2. Item 1A

Appeal of Planning Commission Resolution No. 26-05 Regarding Coastal Development Permit No. 19-012 (25200 Pacific Coast Highway, APNs 4459-013-021 and 4459-014-018; Owner, PAR PCH, LLC; Appellant, Jun Hall for Concerned Citizens of Malibu Road, Inc.)

Amended[1] Malibu City Council
Special Meeting Agenda

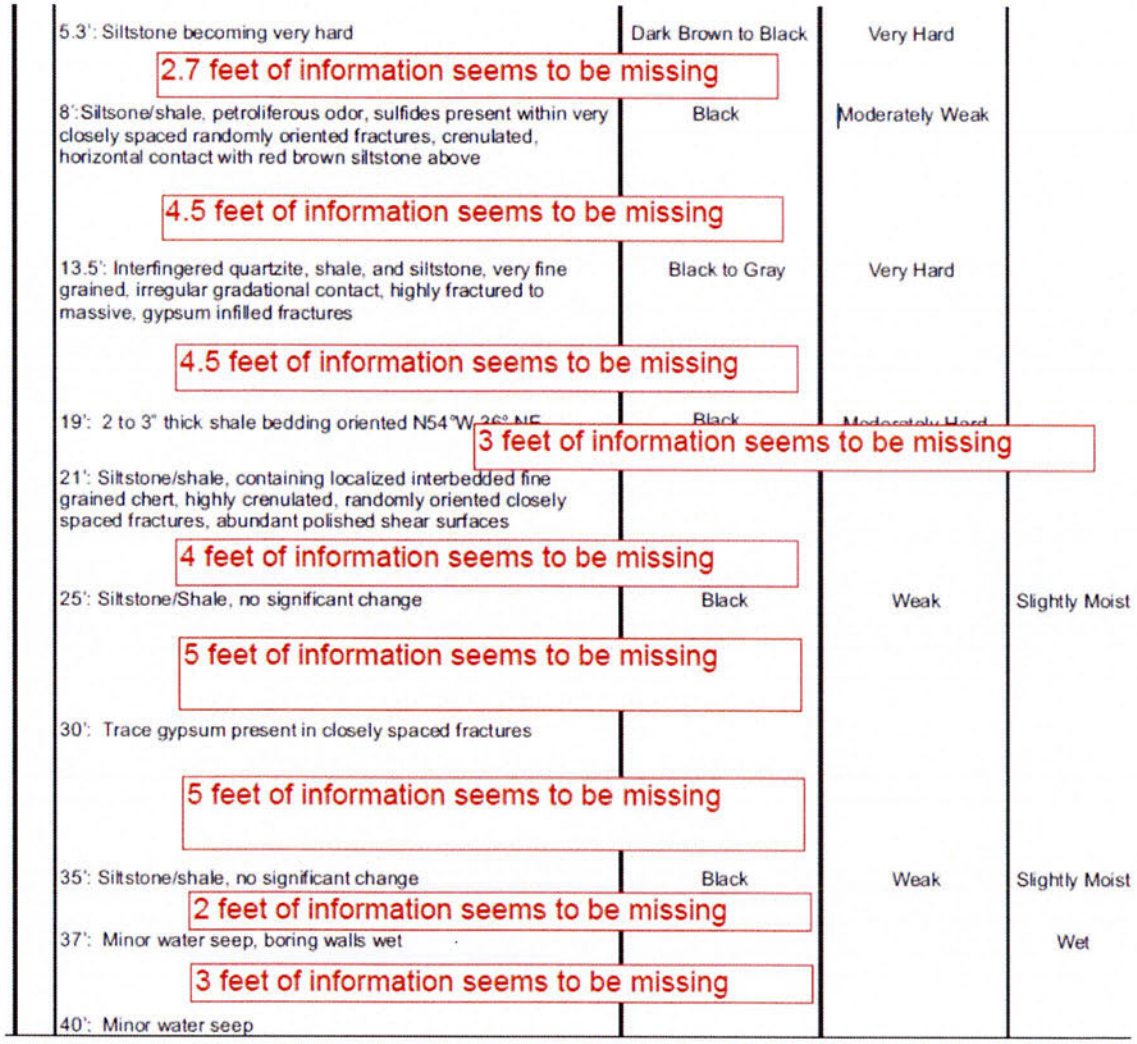
The concerns regarding the characterization of subsurface materials in Feffer's borings remain unaddressed. Specifically:

- Older consultants' reports documented crushed, disturbed, or sheared materials consistent with landslide deposits, while Feffer logs classify similar intervals as "bedrock" without explanation.
- Gaps in log descriptions at depth and a lack of detailed material characterization were not addressed and did not meet the industry standard of care.
- No explanation was provided for discrepancies between historic logs and Feffer's own interpretation.

As stated in the prior technical letter, continuous subsurface investigation is critical to defining landslide geometry and failure mechanisms. Continuous boring logs are essential. Industry standards require logging every vertical inch of the borehole and documenting lithology changes, shear zones, bedding attitudes, fractures, clay seams, and disturbed materials. Terms such as *smashed*, *jumbled*, *pulverized*, *reworked*, *slickensides*, and *polished shear surfaces* are commonly used to describe materials disturbed by landslide movement.

***Figures 7 & 8:** Appellant's photos which are clearly taken from the applicant's property and not from PCH, as is claimed in figure 8.*

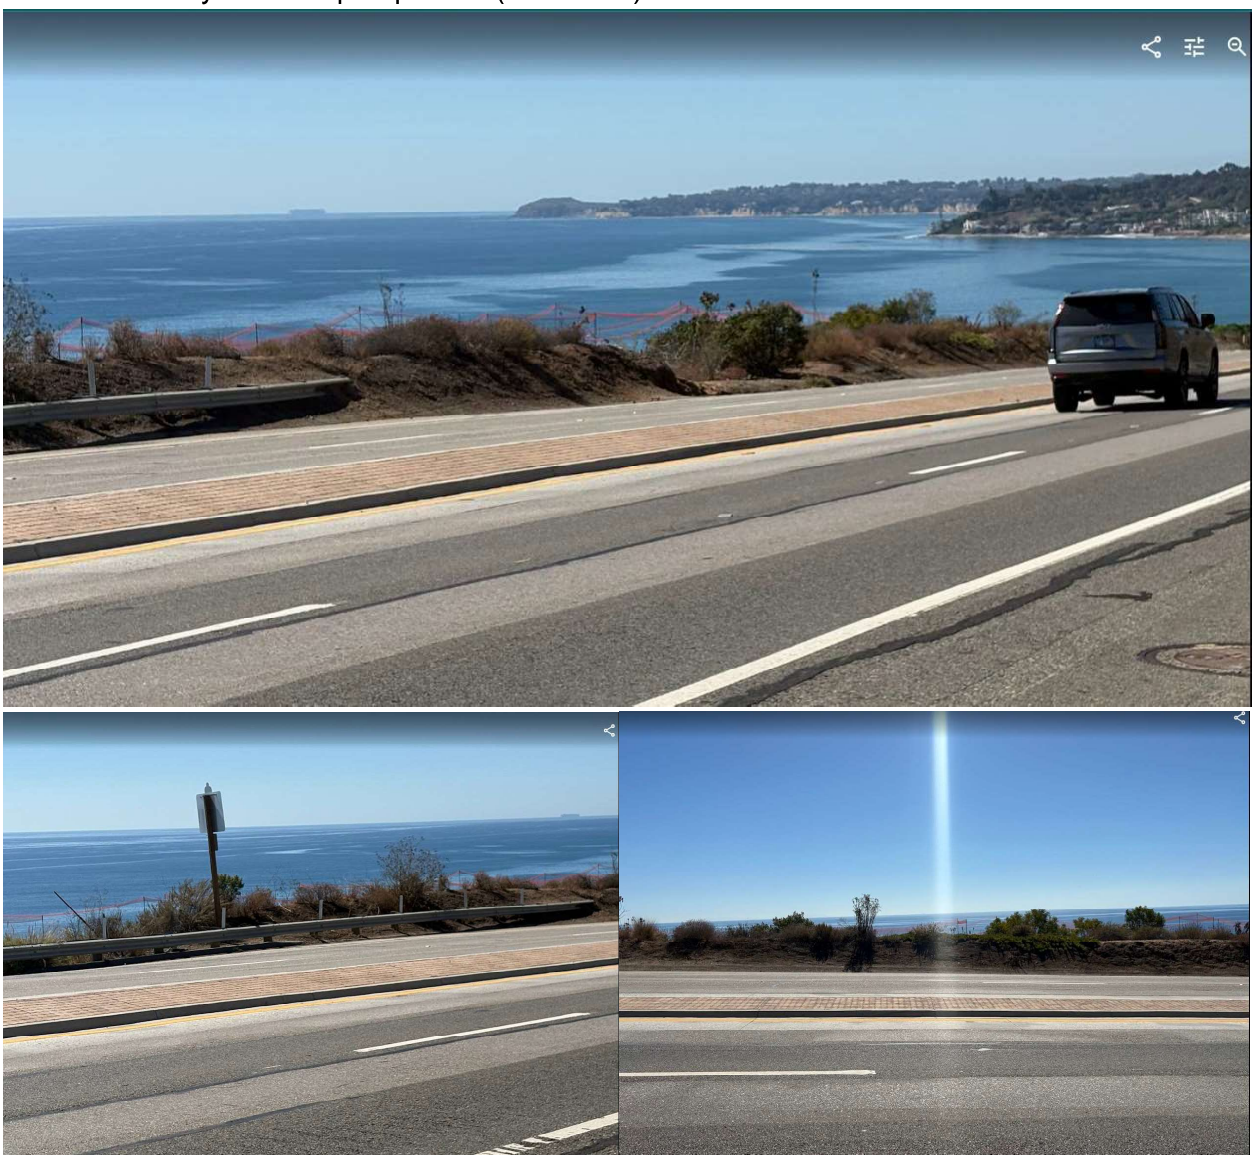
Again, the applicant's photos accurately show the relevant elevations of the story poles vis a vis the PCH roadway and berm. The applicant's photos below and the project rendering provide a clear picture of the minimal view blockage of the house design. Planning staff viewed the poles from PCH, photo documented the same and reviewed the applicant's renderings and have found them reliable and accurate as verified by staff's visits to the property. The appellants assertion

that the house blocks all views of Catalina and Palos Verdes is a contrivance supported by photos taken +-11' below PCH. The photos immediately below, taken by the applicant's representatives, show an entirely different perspective (from PCH).
